***MODIFICATION REQUEST:***

***116a – 122b Epping Road, 259 – 263 Lane  
Cove Road and 1 – 9 Allengrove  
Crescent, North Ryde***

***MP 10\_0037 – Modification 1***

Director-General's  
Environmental Assessment Report  
Section 75W of the  
*Environmental Planning and Assessment Act 1979*

**Figure 2 – Proposed changes to building envelopes – Roof level**

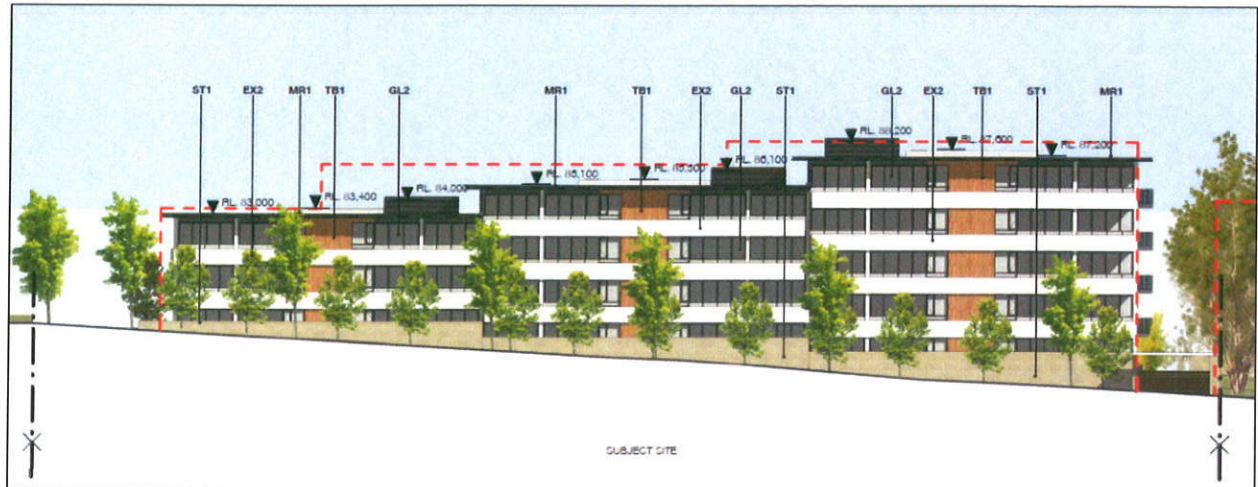
The proponent has provided an envelope study which details the proposed modifications to the building envelopes. **Figure 2** (below) shows the changes at the roof level which provide a general indication of the scope of change. **Figure 3** shows the eastern (Epping Road) elevation.

**Figure 4 – Indicative setbacks to eastern portion of building D**

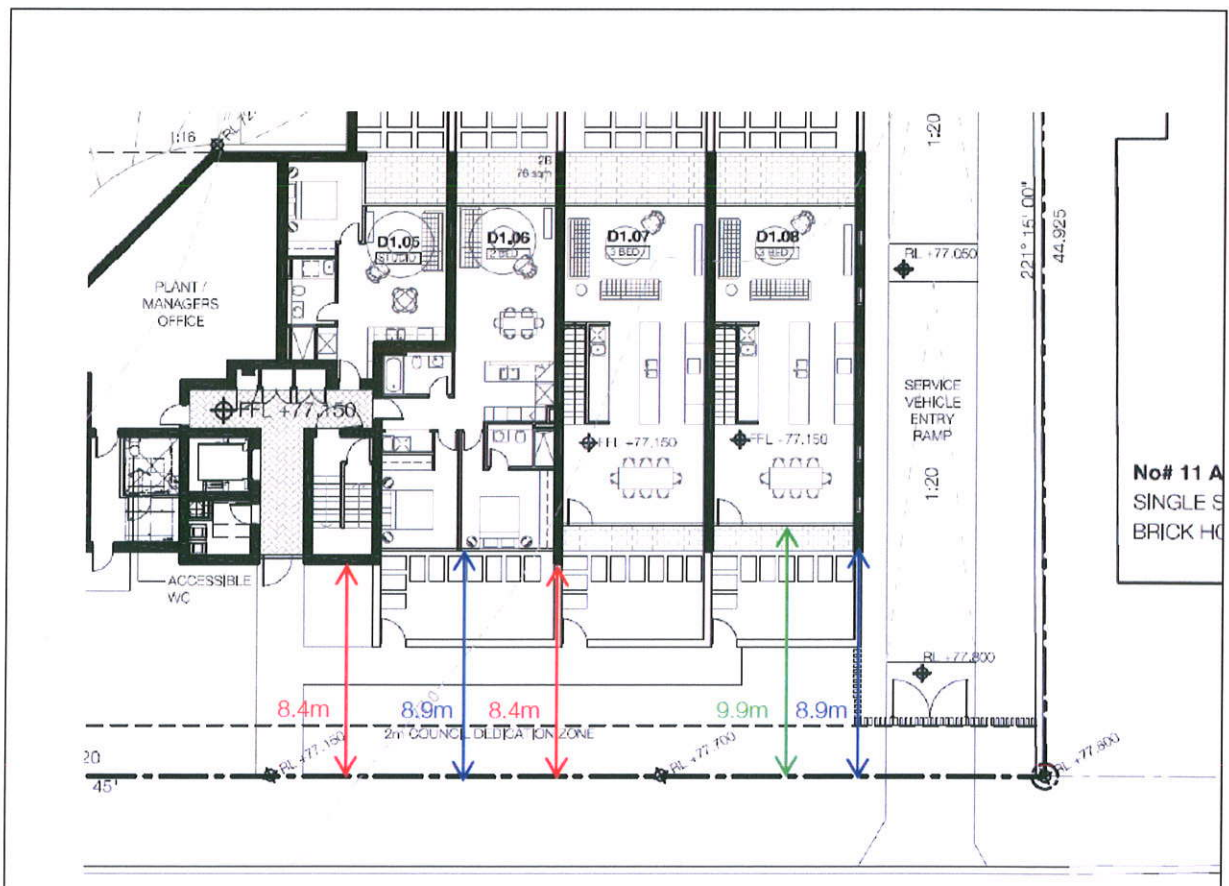
It is also proposed to reduce the setback of building D from Allengrove Crescent from 8.9m to 8.5m. On the indicative floor plans, the façade of the building is stepped with the fire stairs and framing elements setback 8.4m, whilst the majority of the façade is setback 8.9m as illustrated in Figure 4 below. The proposed reduction is supported on the basis that it is a minor change and the proposed envelope can achieve an acceptable relationship to the street.

**Figure 5 – Western (Allengrove Crescent elevation)**

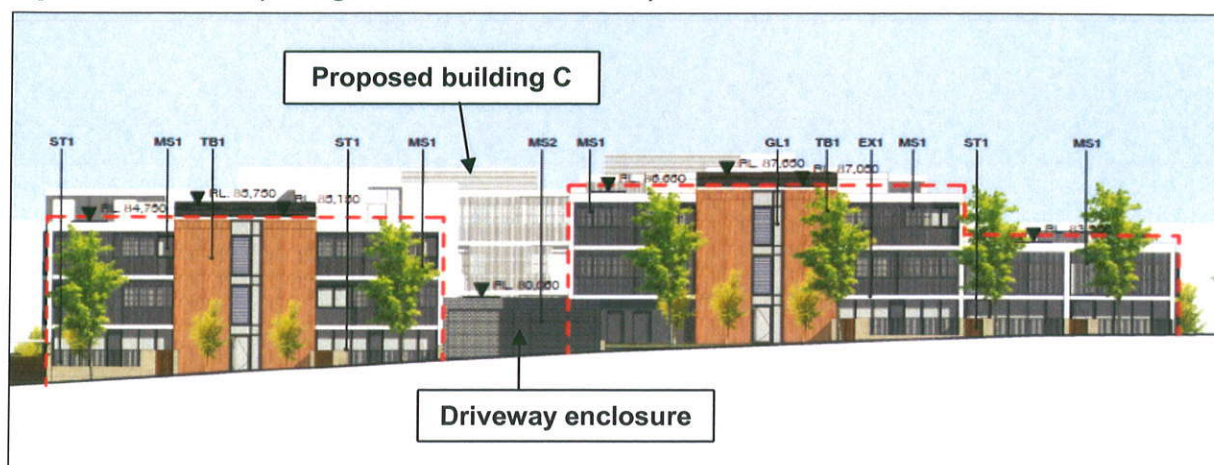
The proposed driveway enclosure would create a link between the two approved building D envelopes at Allengrove Crescent. The enclosure will not be visually prominent being a single building sitting between 2 three storey buildings (refer **Figure 5**). Its visual impact is further mitigated as it would have a greater setback from the street than the adjoining building.
